Kansas Department of Agriculture  
 Division of Water Resources  
**CHANGE: P/D WORKSHEET**

RE: Water Right, File Nos. 7496 & 8580

## DWR FIELD OFFICE APPLICATION FOR APPROVAL TO CHANGE THE PLACE OF USE AND/OR THE POINT OF DIVERSION

## GMD3 Change Review

**Point of Diversion Change  
WR'(s) 7496 & 8580**

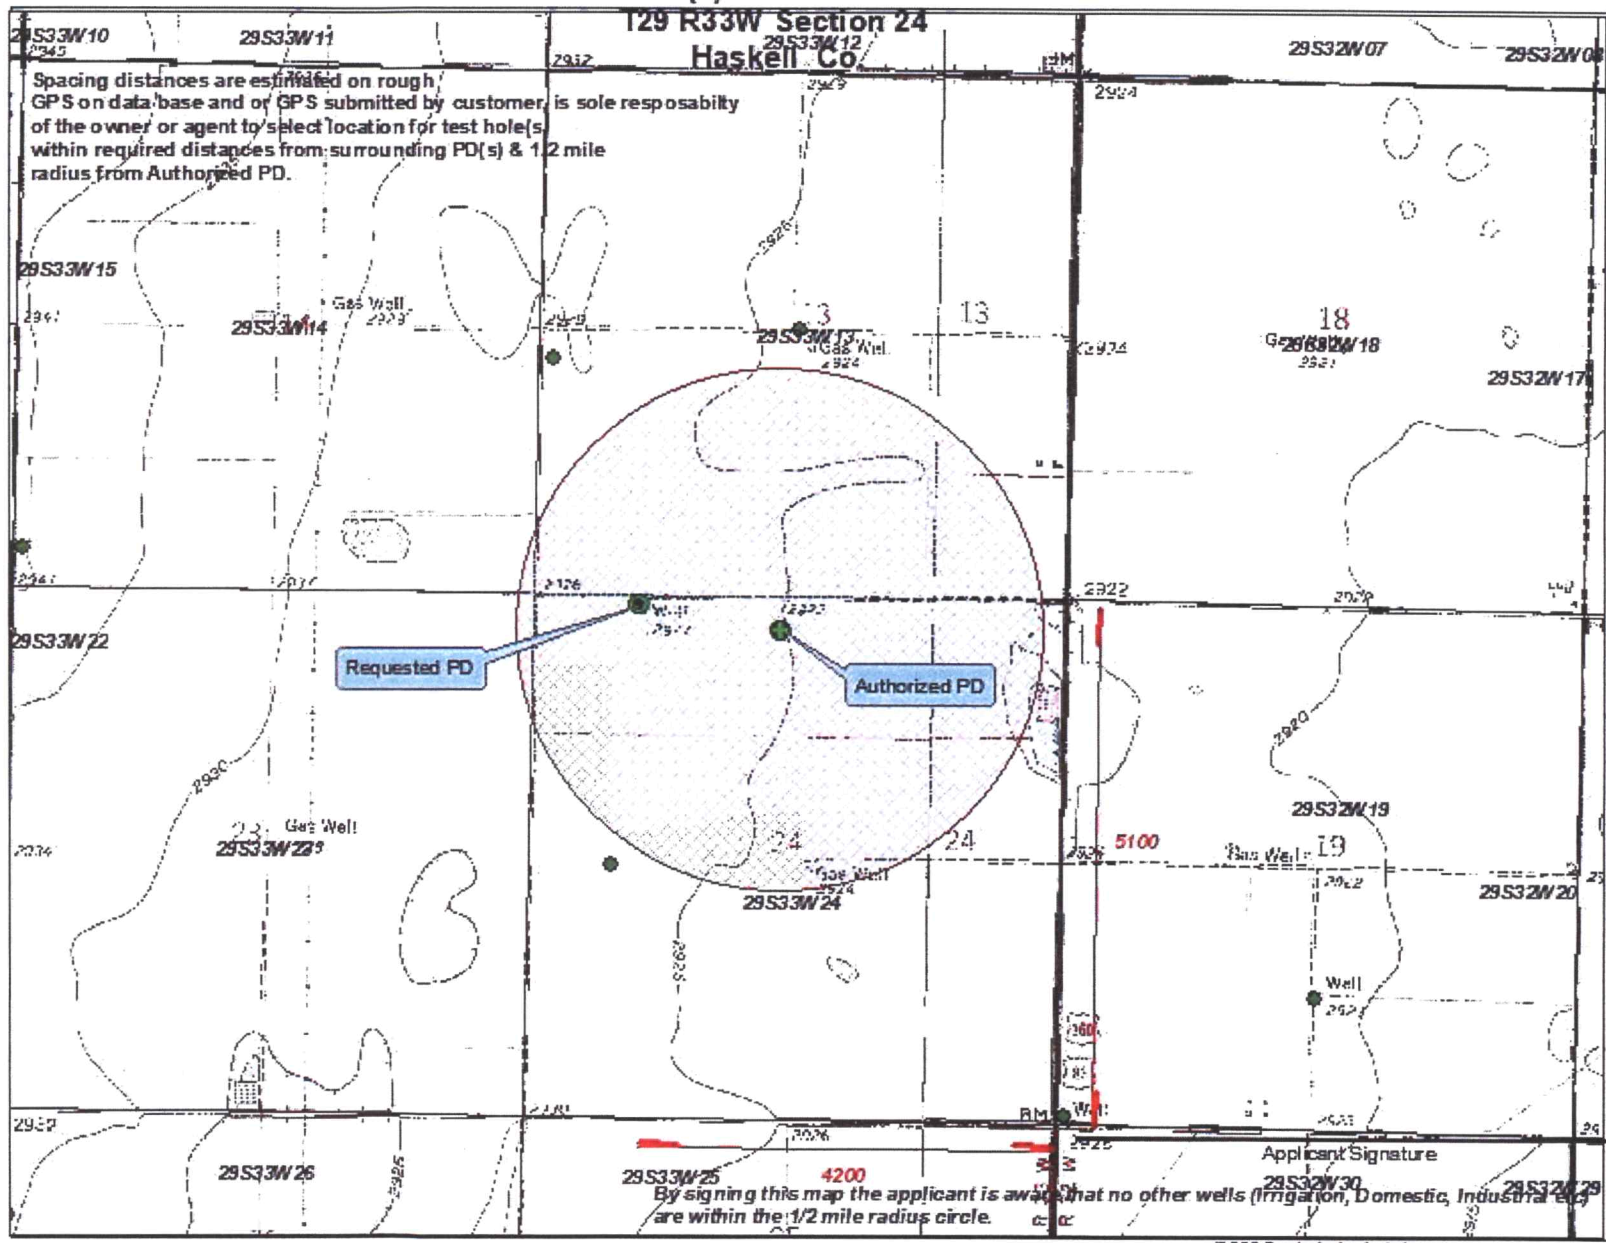
We have completed the review of the applications for the above referenced water rights. The proposed change in point of diversion is in accordance with current area rules, K.A.R. 5-23-3, as it pertains to distance moved and minimum spacing to neighboring wells. Change applications were approved in 2014 to move the well to the currently authorized point of diversion. The diversion was never completed, hence the need to move the authority back to the original proposed location. Since the applicant never completed the new well and has been using the original well, there are no new effects to the area to evaluate. This change will reauthorize the original well and put the applicant back into compliance. GMD3 sees this move as reasonable and therefore recommend that the application be approved.

ft. North	ft. West	
Authorized PD	4928	2848	Sect 24-29-33
Proposed PD	5100	4200	
Difference	-172 n	-1352 w	
$a^2 + b^2 = c^2$	29584	1827904	1362.897 foot move NW

**Application is to revert bac to original location. New well was not drilled after change approval in 2014. Has been using the original well the whole time.**

Is a waiver needed: Move back is less than half mile. Minimum spacing is still met.

There would be no additional effects with the move since it is original well that has been used all along while new well was not developed.

Recommendation: After review of all available information, current area rules are met.
